Western States Minerals Corp.

RE: Response to DOGM letter outlining issues raised during the Phase II and III bond release review and technical analysis associated with the J.B. King reclaimed minesite, ACT/015/002, Folder #2, Emery County, Utah

WSMC response to DOGM

TITLE: Soil Location Map	
PROJECT: J.B.KING RECLAMATION	
STATE: UTAH	COUNTY: EMERY
SCALE: 1"=100'	DRAWING NO.:
DATE: 3-5-99	DRAWN BY: REV./10/99

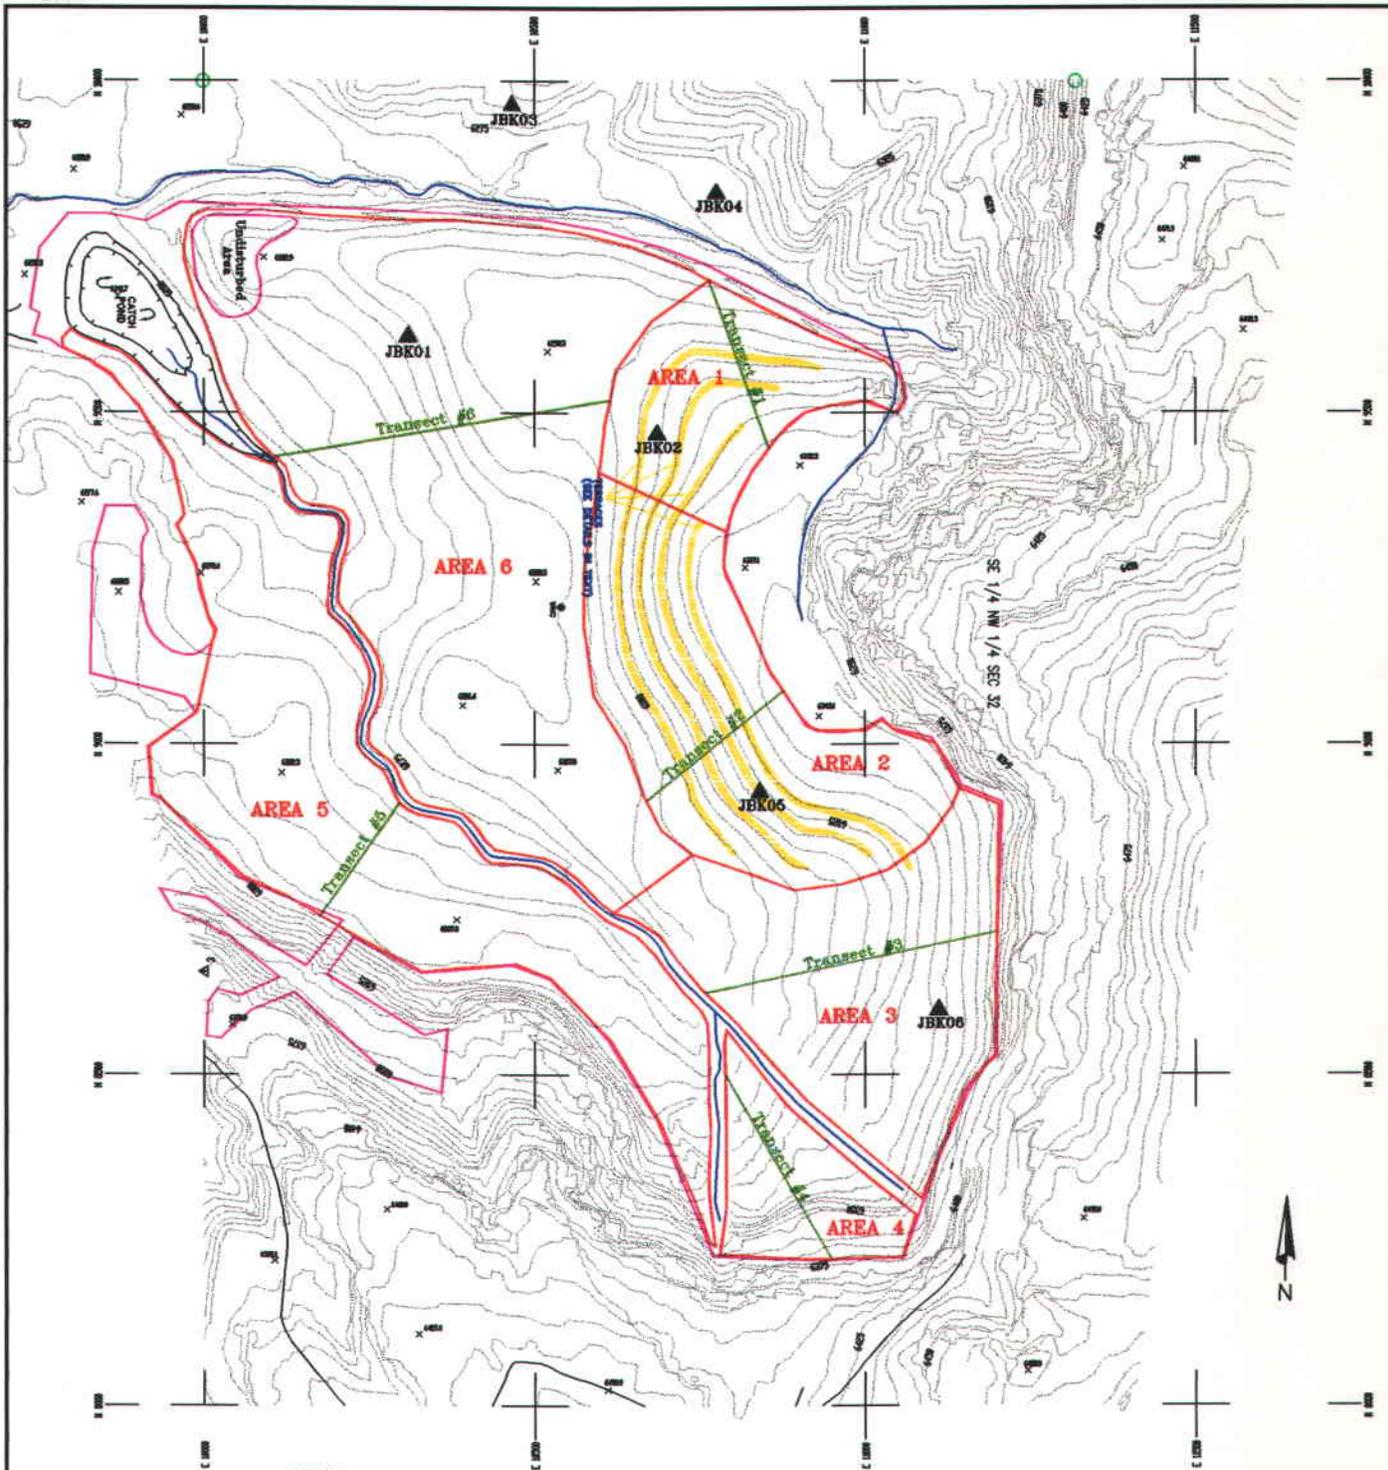
An annual soil loss estimate, using the RUSLE (Revised Universal Soil Loss Equation) was submitted for the J.B. King Mine. Elements of the RUSLE equation (e.g. "K" factor) require specific physical soil parameters (including, but not limited to: soil permeability, soil structure, %very fine sand, coarse fragment %by weight, % rock cover, and soil density.)

The data used to determine the K value (e.g. the specific physical soil parameters) were submitted. Please provide the methodology used to obtain the K factor selection of the "data" transects. This should be presented to provide justification for the values used.

WSMC answer- The J.B. King site was divided into six (6) "data" evaluation areas. Each area was given a representative transect. These areas were selected based upon their internal similarities of soil type, vegetative cover, composition of rock fragments, and topography. The six areas that were selected provided a good representation of the site and kept the calculations to a reasonable level. In June 1993, several soil samples were collected and analyzed for the entire suite of soil nutrient characteristics and particle size gradation (e.g. % sand, silt, and clay – and determination of the USDA texture). The laboratory results are attached to a previous report submitted to DOGM, entitled "Soil Loss Evaluation of the Reclaimed J.B. King Mine- dated May 1999). The transect areas were selected, in part, to correspond to the soil samples collected (e.g. Area #1 corresponds to soil sample JBK02, Area #2 to JBK05, Area #3 to JBK06, Area #4 to JBK03, Area #5 to JBK04, and Area #6 to JBK01). The location of where these soil samples were collected is shown on the attached map entitled *Soil Location Map*. The values actually used in the K factor calculation differ slightly from the sampling data, to adjust for changes that have occurred over time and to account for the sample collection methodology. The two modifications that were made included: 1) a slight increase in the percent organics, based on the addition of biosolids and success of revegetation from 1993 to present; and 2) the percent silt and clay were decreased slightly to account for the greater proportion of rock fragments that exist, but were not initially sampled. Samples JBK03 and 04 were collected off-site, but were determined to correlate with Areas # 4 & 5, respectively; and were therefore utilized to represent those areas, accordingly.

See map and results of
sampling sediment pond
solids. Sample # SPM-1
The areas discussed and
data presented are
~~highlighted~~ for your
review.
